Access Compliance Report

Public Rights-of-Way

(Curb Ramps)

Intersection ID: 52226	Main Street: AMESBURY_HILL_DR	Cross Street: AUBURN_HILL_LN	Location: SW
ADA ID: 631577E3A794	Ramp Type: Perp	Initial Pass/Fail: Fail	Overall Compliance: No
Severity Score: 10			
Codes/Mitigation Info/Possible Solution		Field Measurements/Component Compliance

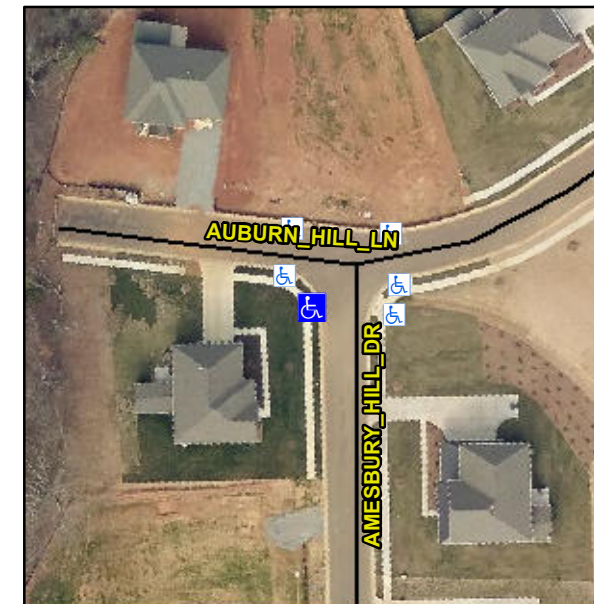
R304.5.1, R304.5.3

Compliance	Description	Data	Compliance	Description	Data
N/A	Ramp Length (in)	50.0	Yes	Ramp Slope (%)	6.5
No	Ramp Width (in)	45.5	No	Ramp XSlope (%)	3.1
N/A	Flare Type LT	N/A	N/A	Flare Type RT	N/A
N/A	Flare Slope LT (%)	N/A	N/A	Flare Slope RT (%)	N/A
N/A	Flare Traversable LT?	N/A	N/A	Flare Traversable RT?	N/A
N/A	Landing Length (in)	N/A	N/A	DWS Provided?	N/A
N/A	Landing Width (in)	N/A	N/A	DWS Contrast?	N/A
N/A	Landing Slope (%)	N/A	N/A	DWS Length (in)	N/A
N/A	Landing X Slope (%)	N/A	N/A	DWS Full Width?	N/A
N/A	Landing Curb? (Y/N)	N/A	N/A	DWS Offset (in)	N/A
N/A	Shared Landing?	N/A			
N/A	Gutter Ponding?	N/A	N/A	Gutter Slope (%)	N/A
N/A	Gutter Lip Ht (in)	N/A	N/A	Gutter X Slope (%)	N/A
N/A	Painted X Walk1?	No	N/A	Painted X Walk2?	N/A
	X Walk 1 Direction	To E		X Walk 2 Direction	N/A
N/A	X Walk 1 Width (in)	N/A	N/A	X Walk 2 Width (in)	N/A
	X Walk 1 Slope (%)	10.5		X Walk 2 Slope (%)	N/A
	X Walk 1 X Slope (%)	1.7		X Walk 2 X Slope (%)	N/A

Remove & Replace Entire Ramp.
